Office Action Summary

10/691,252

BUCHMANN, MICHAEL

DETAILED ACTION***Claim Rejections - 35 USC § 103***

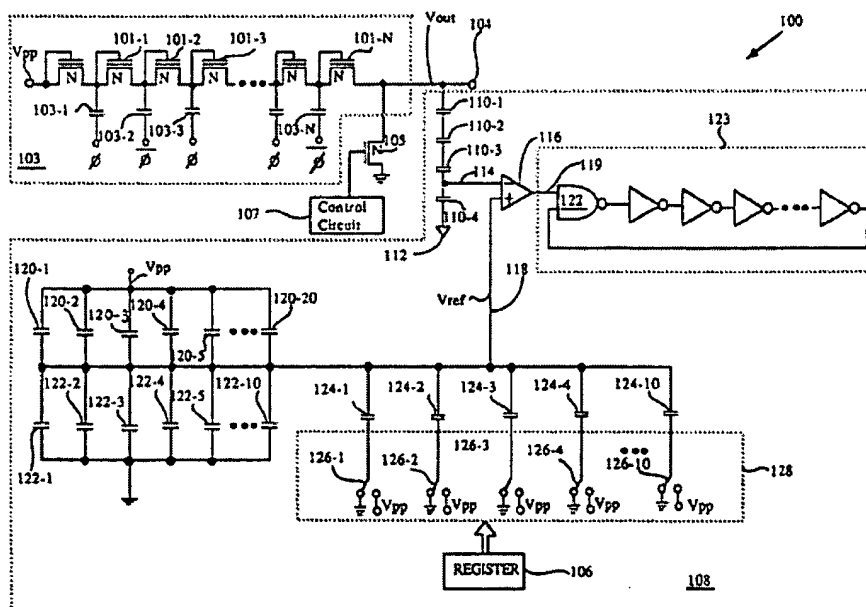
2. Claims 1-8 are rejected under 35 U.S.C. 103(a) as being unpatentable over Kazerounian et al. (USP 5,086,974) in view of Yu (USP 6,304,007). Kazerounian discloses a capacitive multiplier circuit having a diode chain (103) and a charge pump circuitry (128) that connected between the input and output of the multiplier circuit (100). See figure below.
